**PECK FLANNERY GREAM WARREN  
ARCHITECTS, LLC**

RE: New Rineyville Elementary School  
Rineyville, Kentucky  
Architect File No: 0508  
BG# 05-116

**Change Order Request**

# MODIFICATIONS TO BOY'S RESTRM. 157 & 230

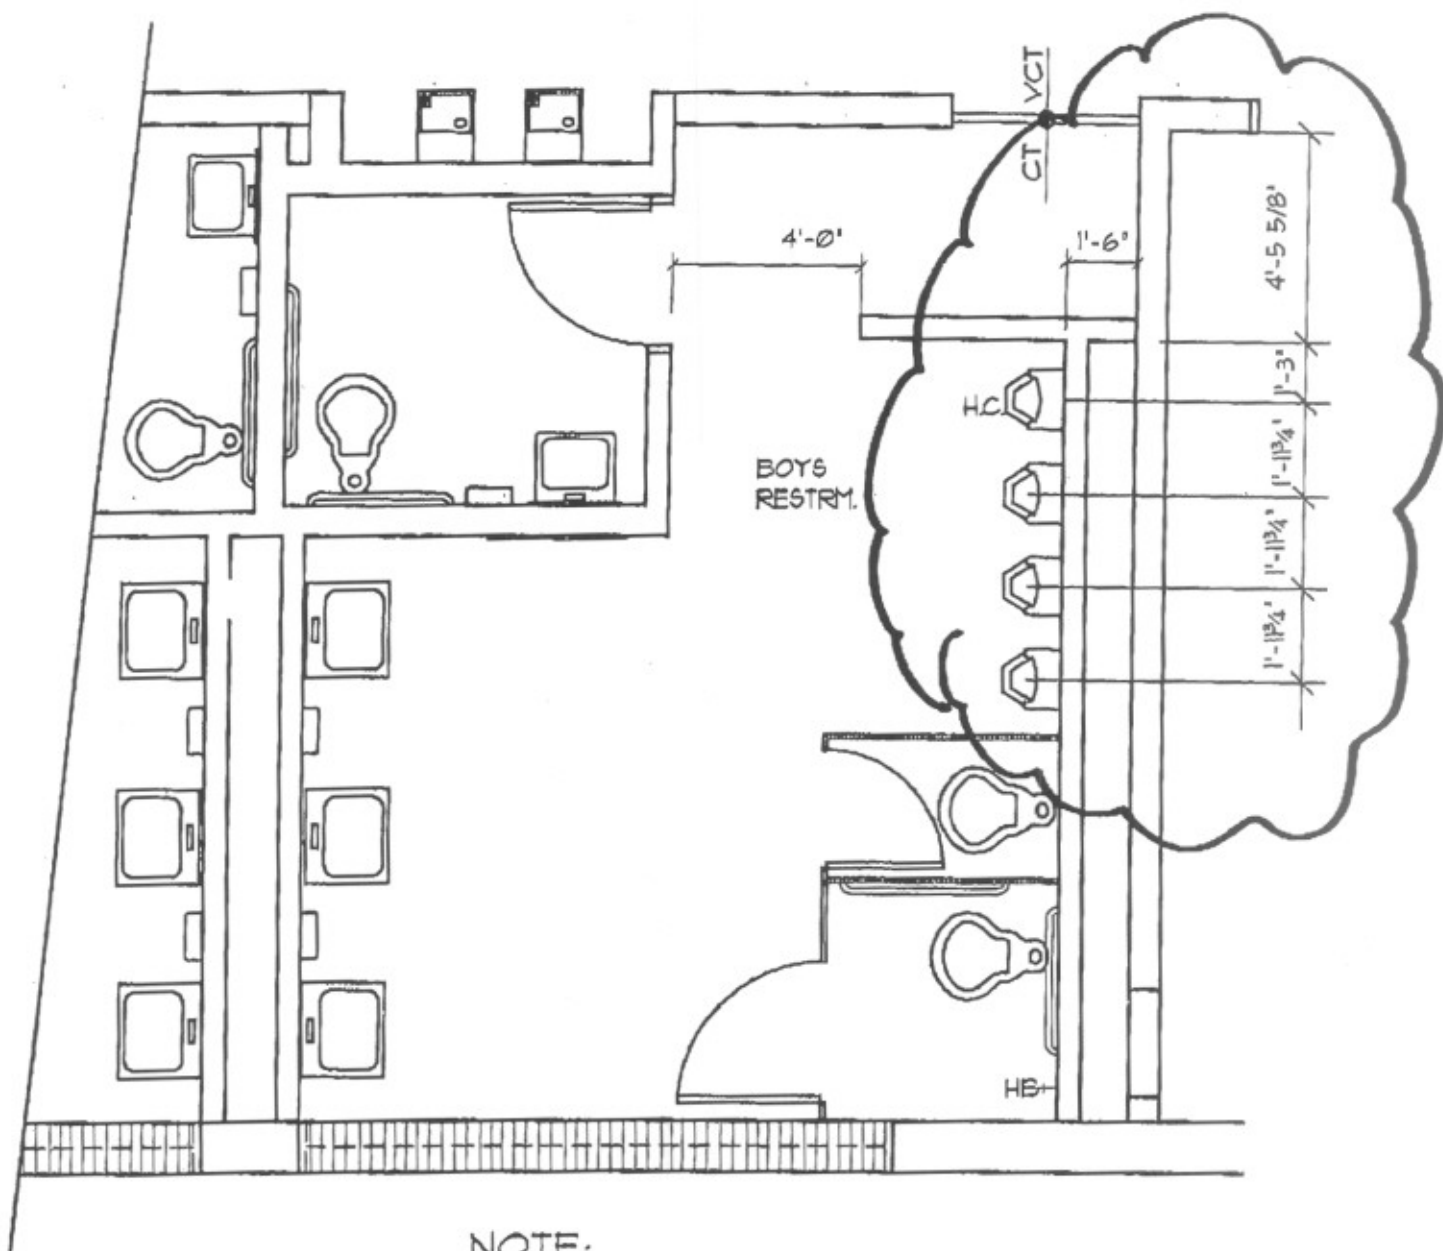
Attached is a copy of our drawing MOD.22 dated August 14. This drawing adds one urinal each in Boys 157 and Boys 230. Please provide a cost proposal to add two additional urinals to project.

Via a copy of this transmittal I am asking Nami Nahid to determine if the piping serving the urinals will require resizing and report findings directly to Knight's Mechanical.

WE PROPOSE TO FURNISH ALL LABOR, MATERIALS AND EQUIPMENT TO INSTALL TWO ADDITIONAL URINALS AS DIRECTED IN ROOMS 157 AND 230. INCLUDED IS AS FOLLOWS:

1) 2-URINALS @ \$322.50 EA.	\$ 645.00
2) 4-CORE DRILL HOLES @ \$ 50.00 EA.	\$ 200.00
3) 1-LOT OF ROUGH IN MATERIAL	\$ 200.00
4) 16 HOURS LABOR @ \$50.00 PER HOUR	\$ 800.00
